**ATTACHMENT 9
LICENSE AMENDMENT REQUEST
EXTENDED POWER UPRATE
CORE OPERATING LIMITS REPORT (COLR)
MARKUPS**

**FLORIDA POWER & LIGHT
ST. LUCIE NUCLEAR PLANT UNIT 1**

Core Operating Limits Report

FIGURE 3.1-1a
Allowable Time to Realign CEA vs. Initial F_r^T

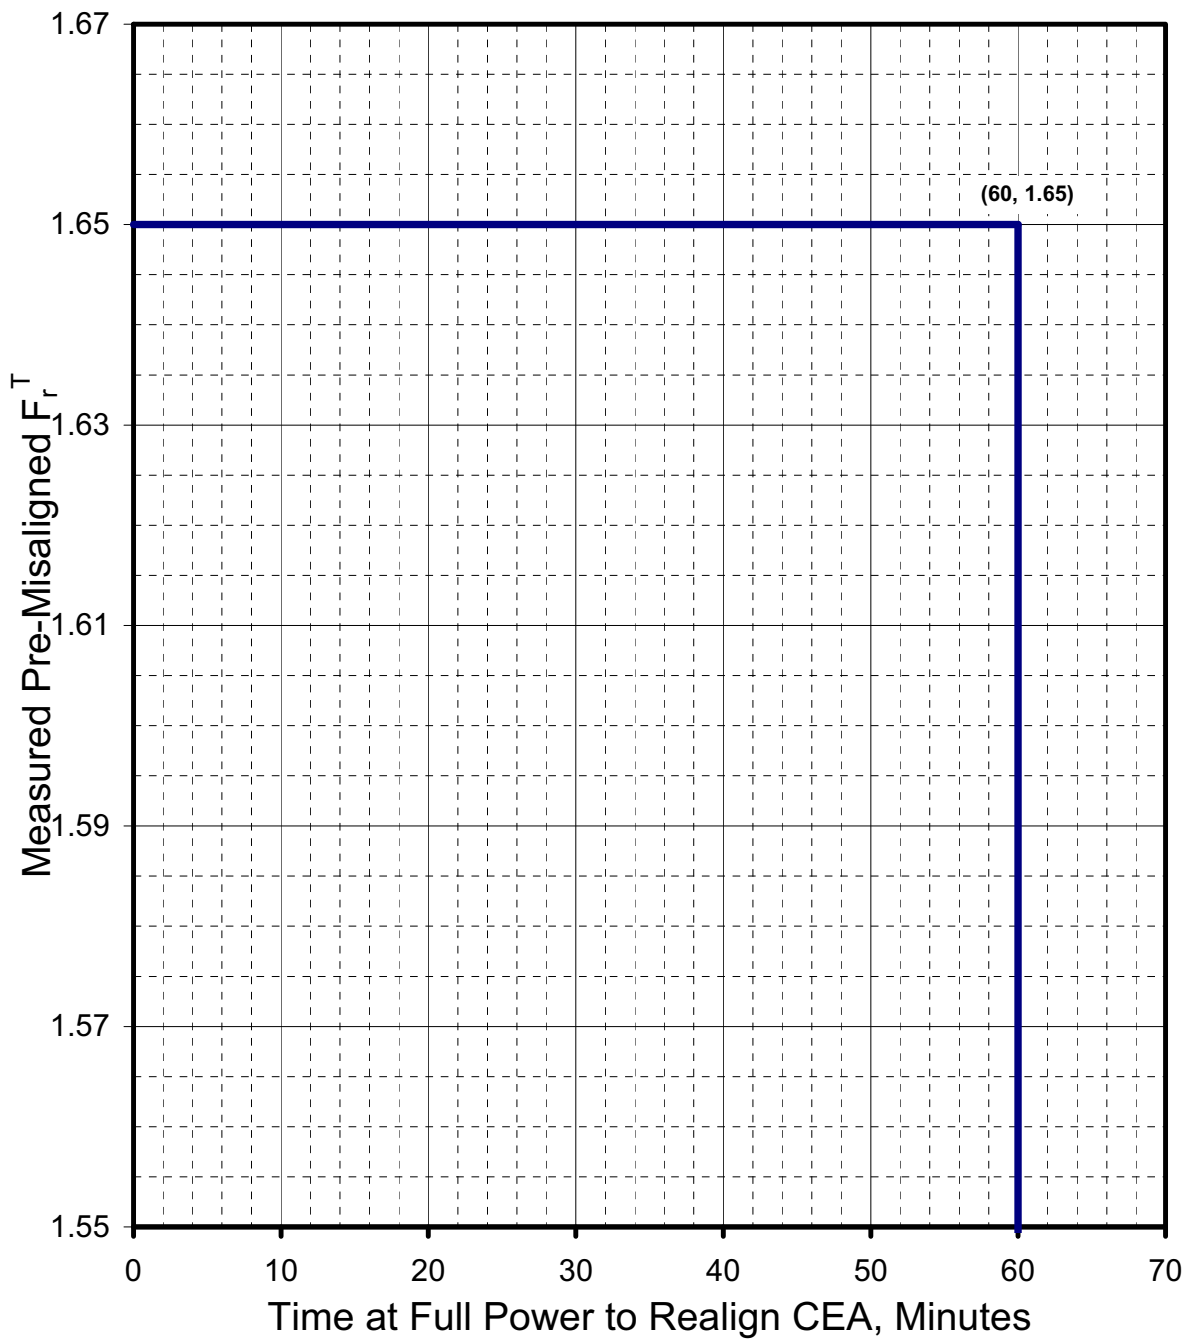
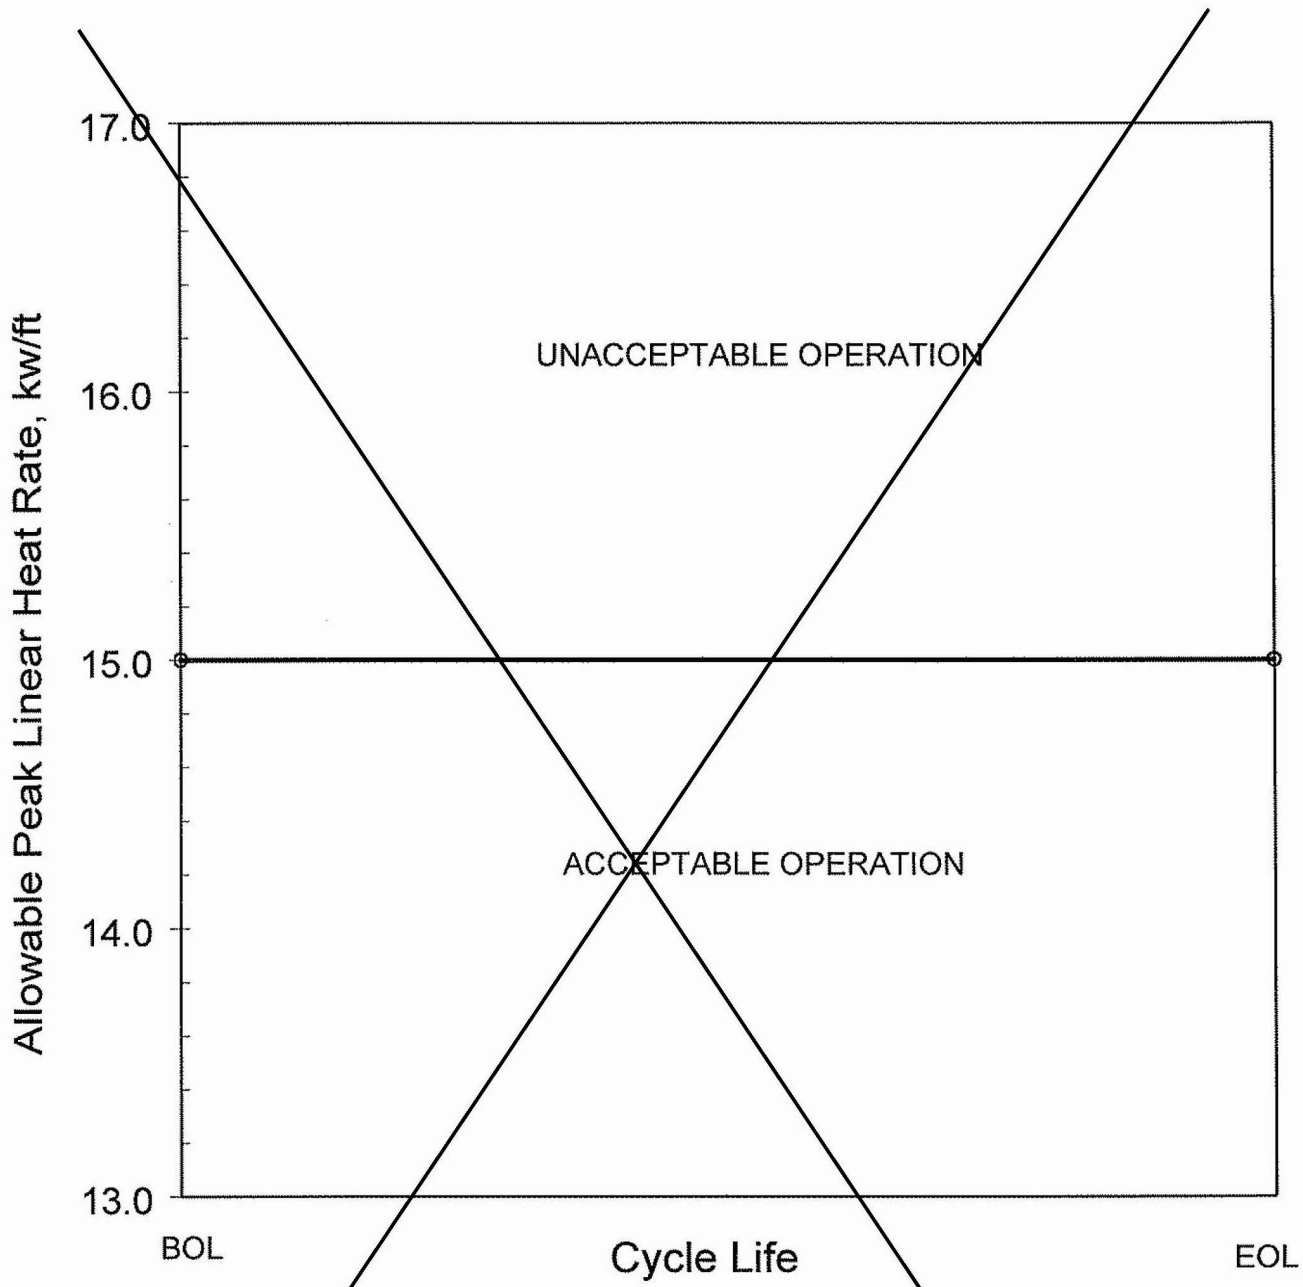
6 of 13 (replaced by Proposed COLR Figure 3.1.1a)

FIGURE 3.2-1
Allowable Peak Linear Heat Rate vs. Burnup

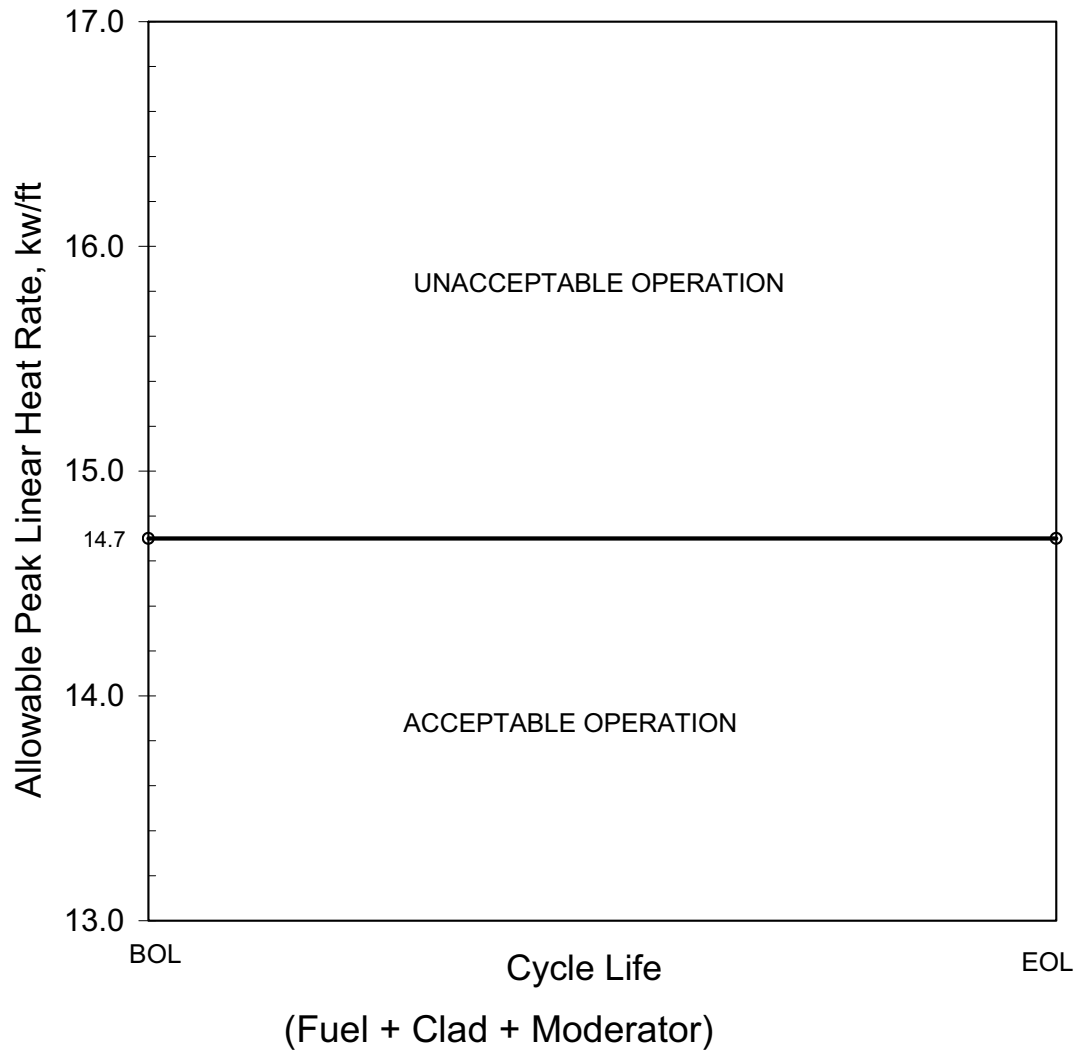
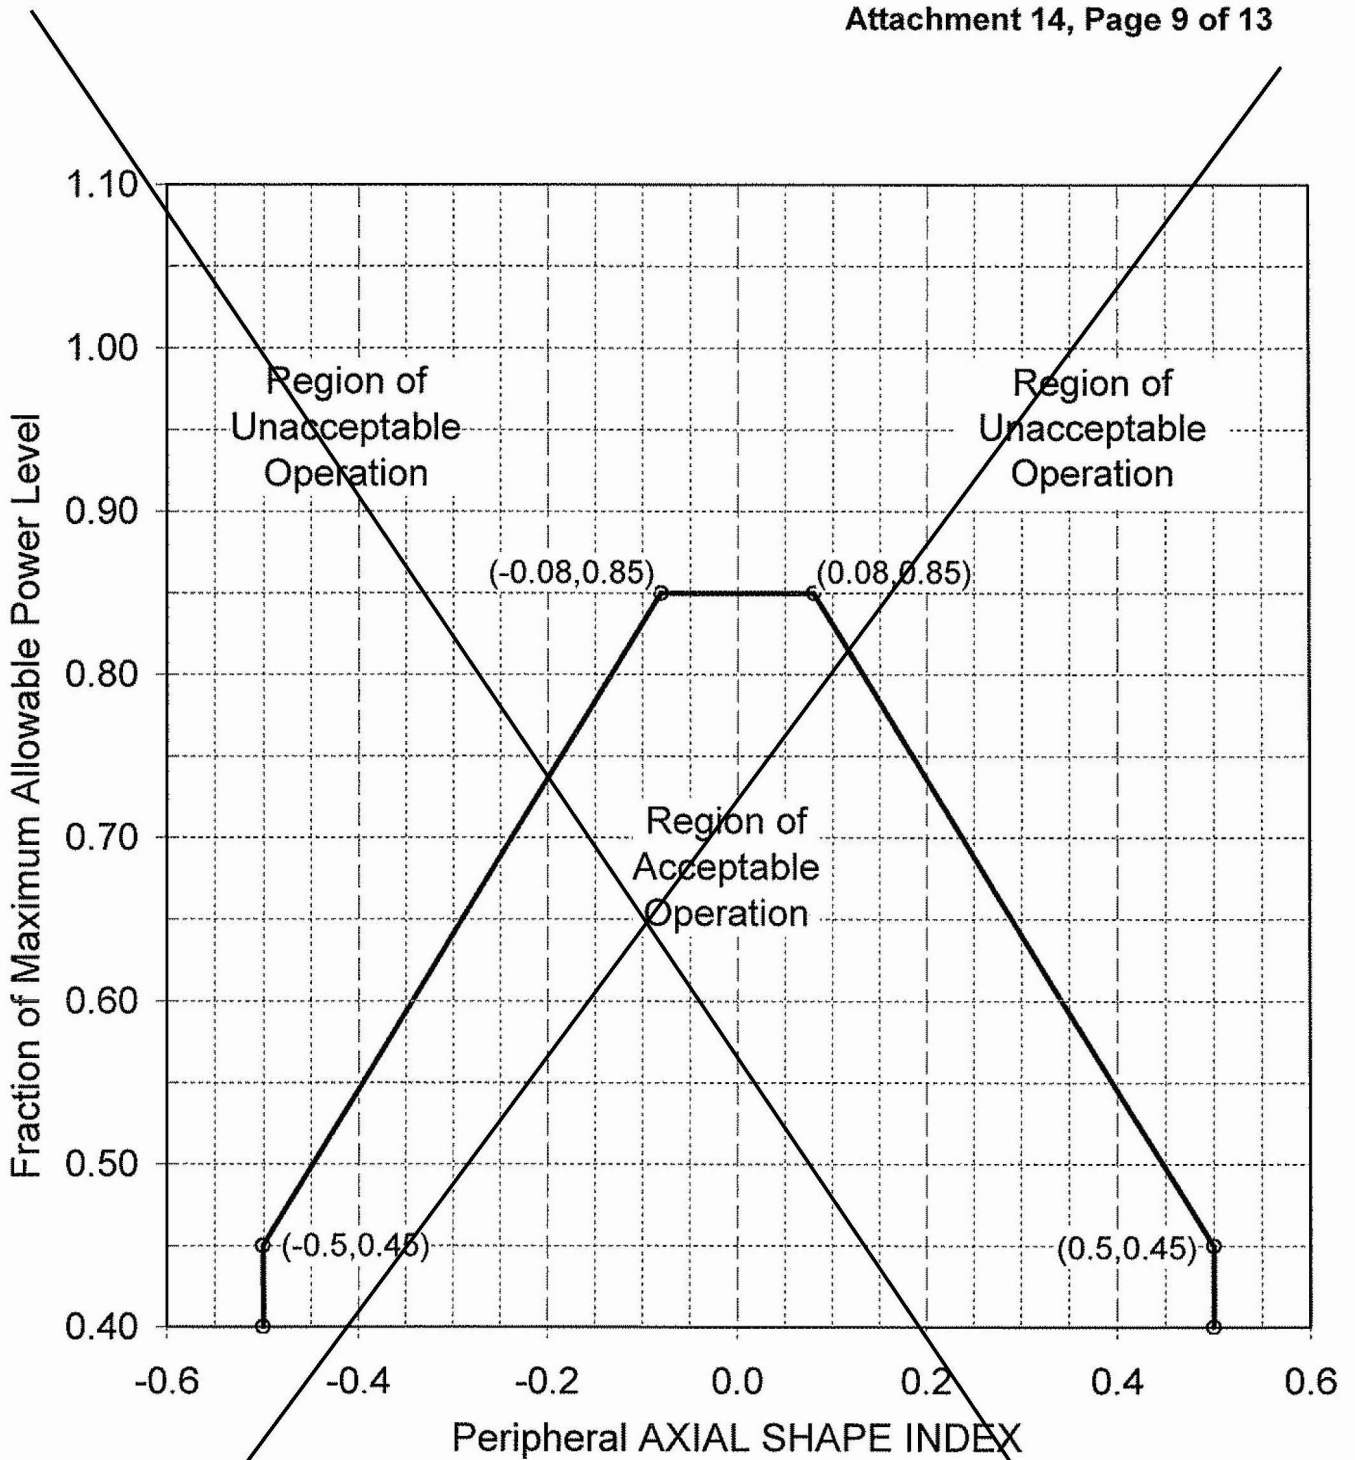
8 of 13 (replaced by Proposed COLR Figure 3.2.1)

FIGURE 3.2-2
AXIAL SHAPE INDEX vs. Maximum Allowable Power Level

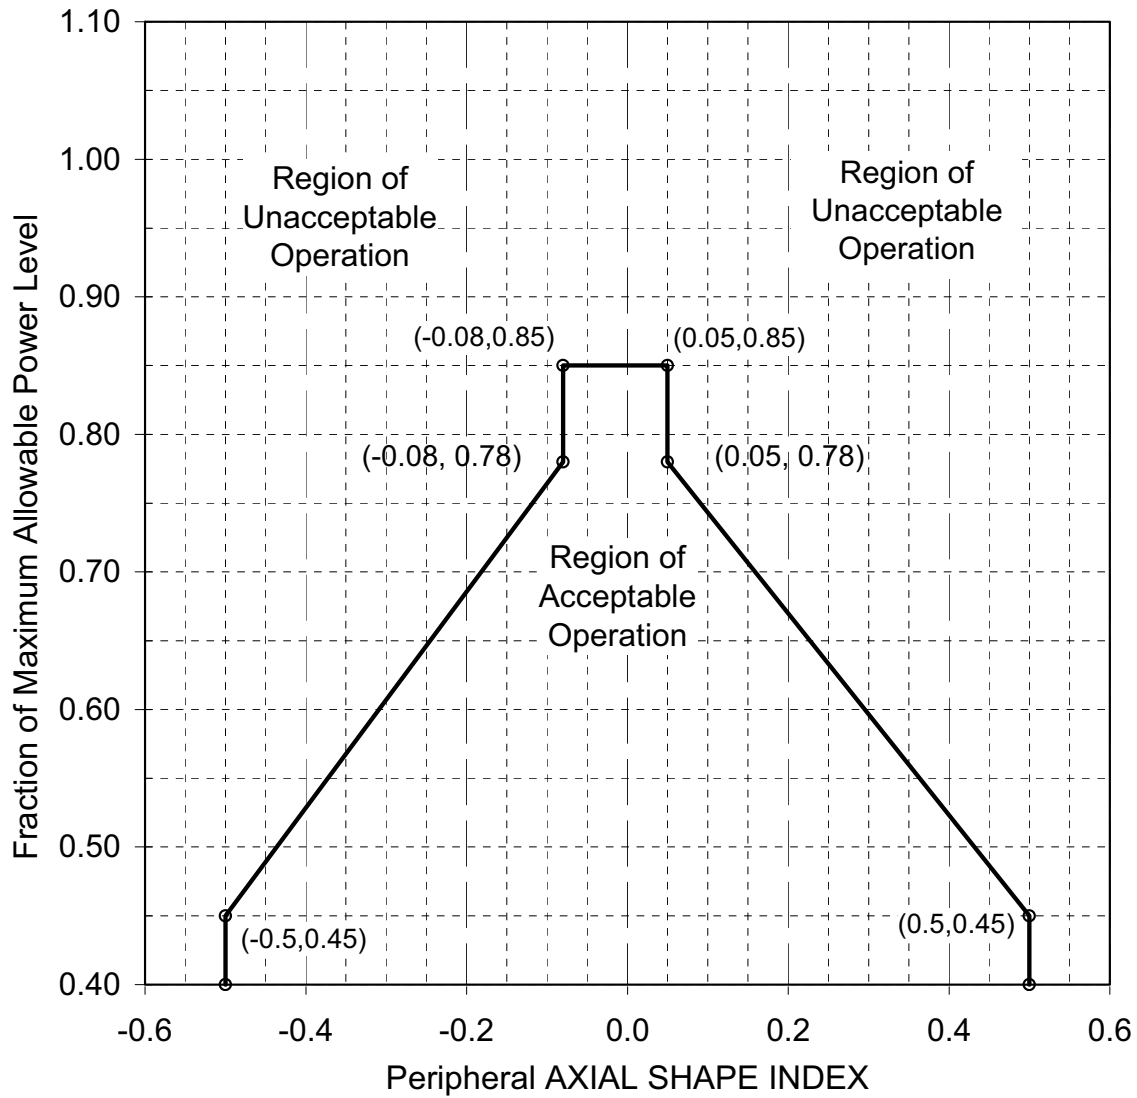
9 of 13 (replaced by Proposed COLR Figure 3.2.2)

FIGURE 3.2-3
Allowable Combinations of THERMAL POWER and F_r^T

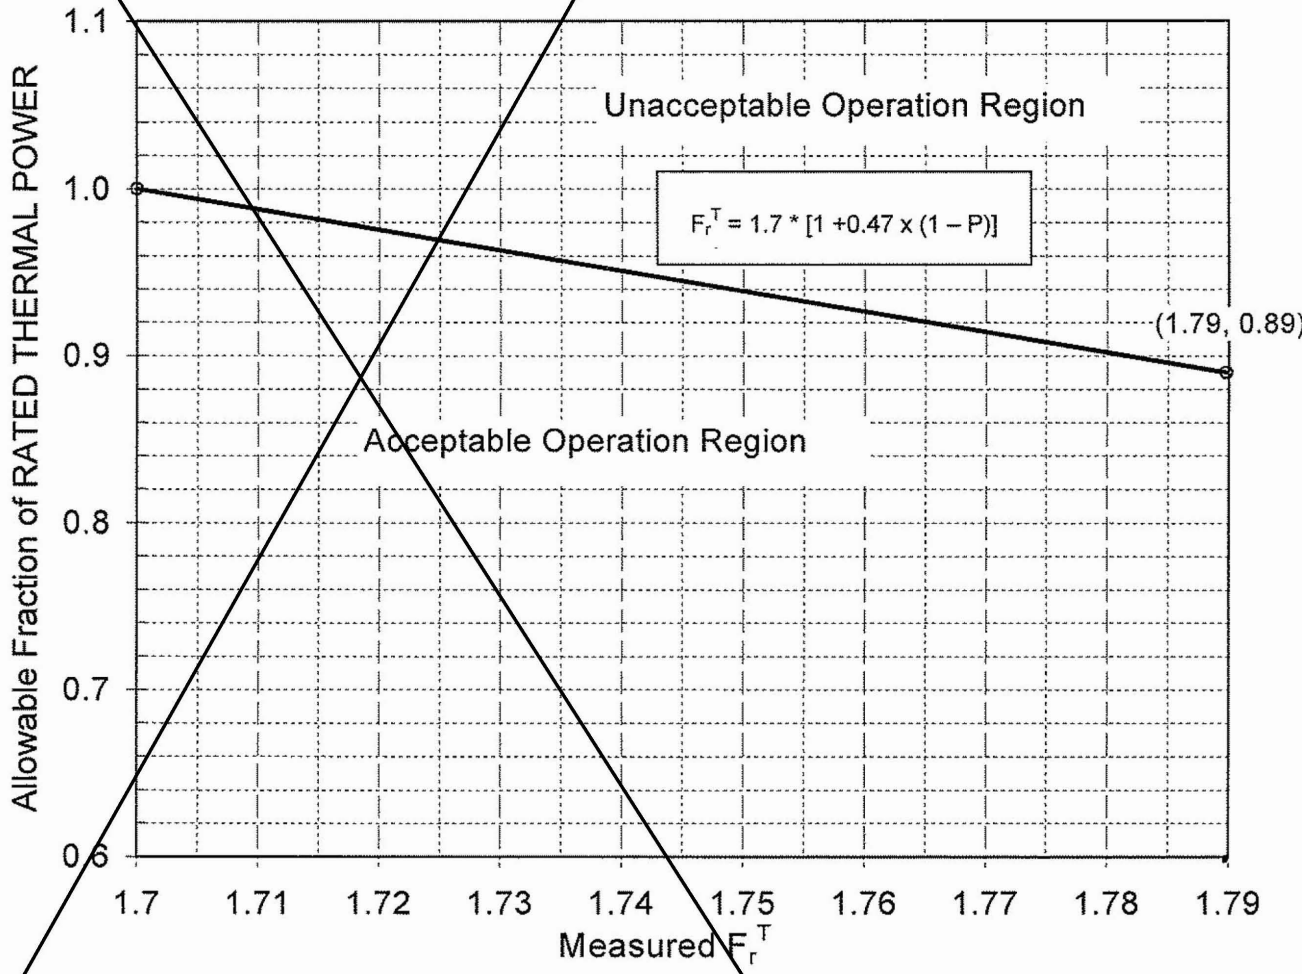
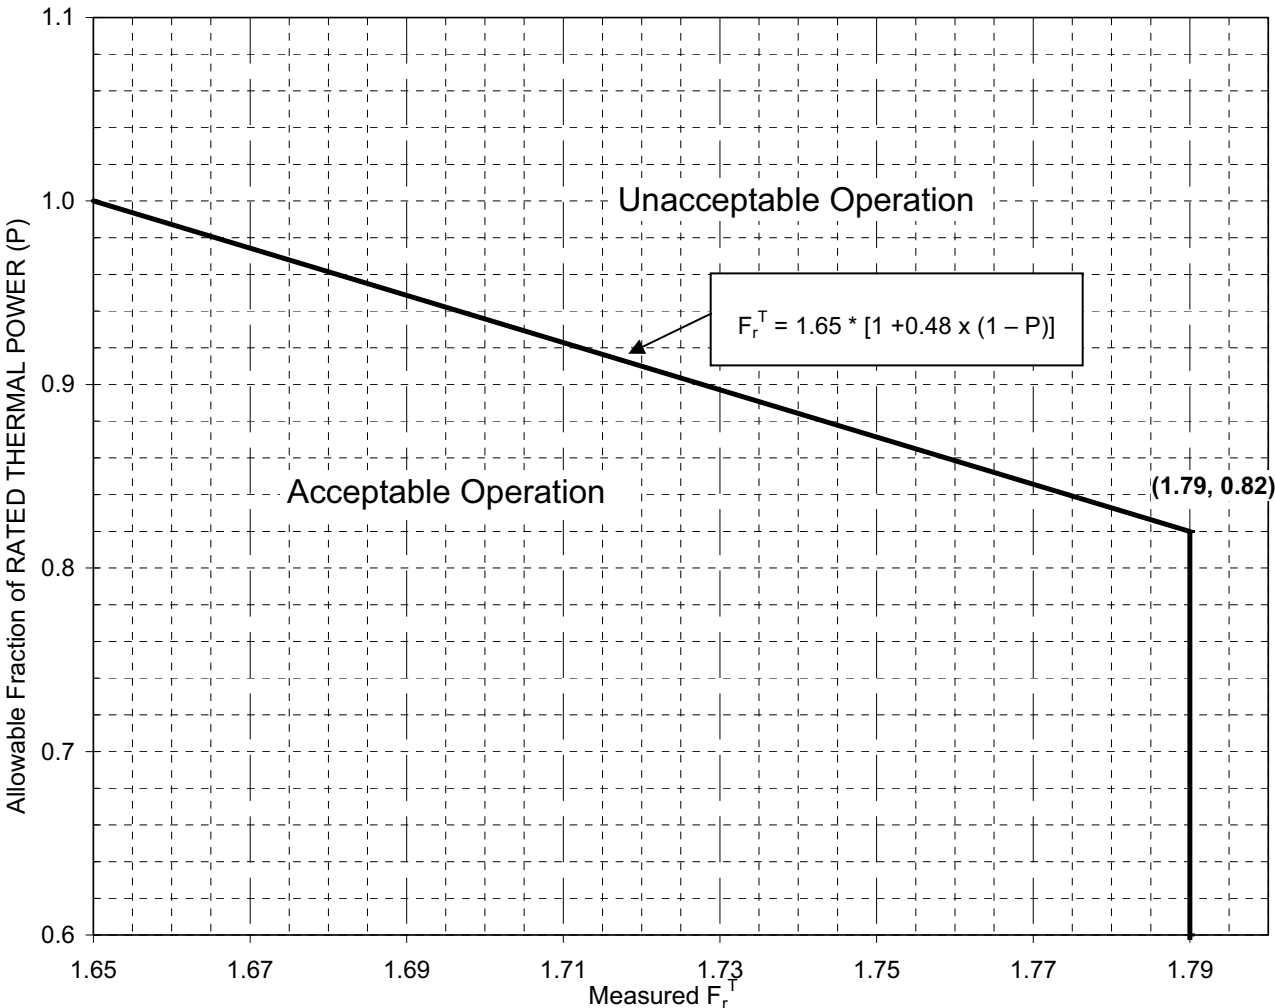
10 of 13 (replaced by Proposed COLR Figure 3.2.3)
